Technical Note No. 500/17

TM500-17 FE-29-01

Subject : Free play in automatic elevator hook-up, adjustment

Effectivity type: DG-500

Figure 2, looking from the rear into the gap at the right-hand side in front of the rudder

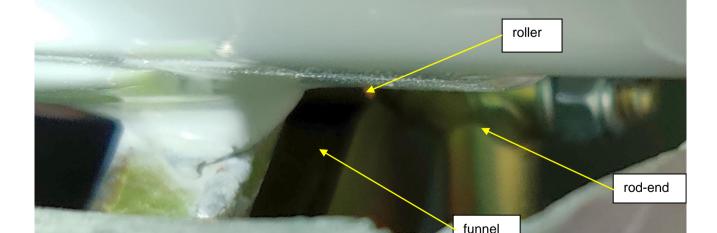
- 2.3 The roller on the rod end has an f7-H8 fit. In case the roller has too much free play on the rod end, or if the roller is no more round you must replace the roller by a new one 5St95/3.
 - After the exchange check the free play and adjust see 2.1.
- 2.4 Use new self-locking nuts and a new cotter pin with instructions: self-locking nut M5 DIN985-8 zn self-locking nut M6 DIN985-8 zn cotter pin 1,5x12mm DIN94St
- 2.5 Rig the horizontal tailplane and when moving it backwards, monitor if you need a higher force. By lifting the elevator trailing edge and looking from the rear into the gap at the right-hand side in front of the rudder, check if the roller is moved up to the front end of the funnel, see also photo at the end of the TN Check the elevator displacements and adjust if necessary.
